Illinois Tollway Base Sheet Revisions

Section M	Base Sheet Drawings	
	Drawing	Modification Summary
		Effective: 2020-03-01
	Pole Assembly (ITS)-Series 1000	
M-ITS-1000	Elevation Views Pole Mounted ITS Element Assembly	
	Use 1 1/2" stainless conduits for power and fiber to ITS Enclosure instead of 2". Corrected the MVDS mounting height on elevation details Use 1 1/2" stainless conduit for ITS Disconnect switch	
M-ITS-1001	General Notes Pole Mounted ITS Assembly	
	Note added on placement of battery enclosure	
M-ITS-1002	ITS Standard Foundation	
	Note added to use 12 ft helix foundation for slopes over 1:6	
M-ITS-1003	ITS Concrete Service Pad	
	Shows option for back-to-back mounted ITS enclosures.	
M-ITS-1004	Cabinet Wiring Diagram - ITS Pole Mounted Enclosure (Solar Powered MVDS) (2 sheets)

DMS WALK-IN
ELECTRICAL PLAN

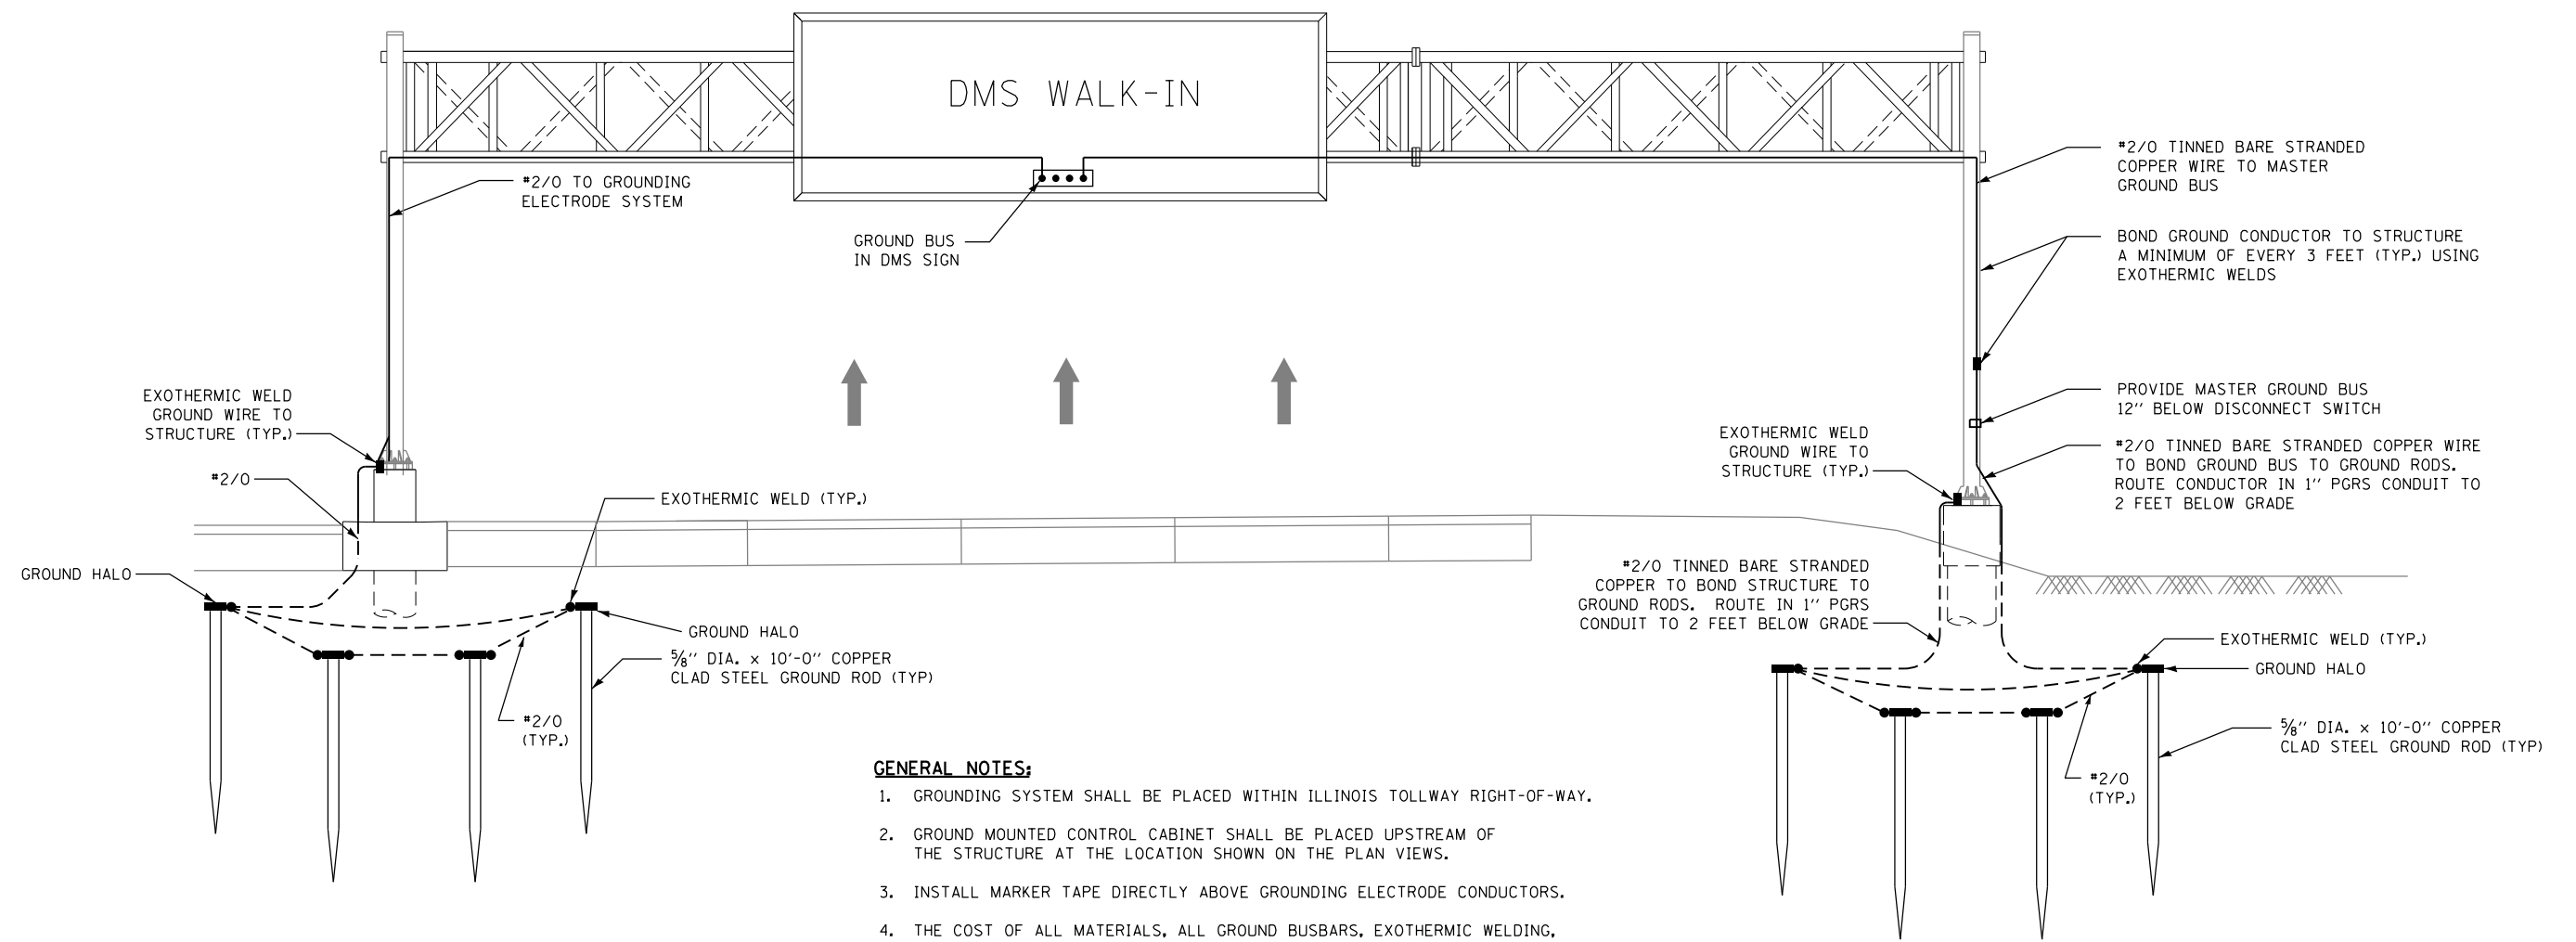
Sheet 1: Revised layout to better accommodate future expansion.	
	Dynamic Message Sign (ITS)-Series 1100	
M-ITS-1100 to M- ITS-1108	DMS (Typical) Revised Type 1 nomenclature to Walk-in (Typical) Revised Type 2 nomenclature to Front Access	
M-ITS-1101	DMS Type 1 Site Grounding Plan	
	Revised to show paved median structure	
M-ITS-1108	DMS Cabinet Wiring Diagram	
	Clarified wiring diagram Updated switch model	
	Cabinet Wiring (ITS)-Series 1200	
M-ITS-1200 to M-ITS-1217	Cabinet Wiring Diagrams New Cat6 surge suppressor Axis T8061 for Axis PoE camera and Ditek for Cohu PoE camera Revised layout for Cisco 4000 switch, power supply, Cohu PoE injectors Revised 1214-1216 plan to remove Cisco switch Added Level 3 Cisco license (L-IE4000-RTU=) Modified gator patch model number	
	Roadway Weather Information System (ITS)-Series 1300	
M-ITS-1300	RWIS Pole, Sensor Mounting Detail	
	General note to have manufacturer to supervise installation and commissioning Revised to show option for co-located CCTV camera and ITS enclosure Clarified the mounting height measured from pavement surface Installed new ITS Enclosure back to back to the RPU enclosure Add ITS Disconnect switch within 50 feet from primary pole Show RWIS cabinet configuration for the 3 electrical services
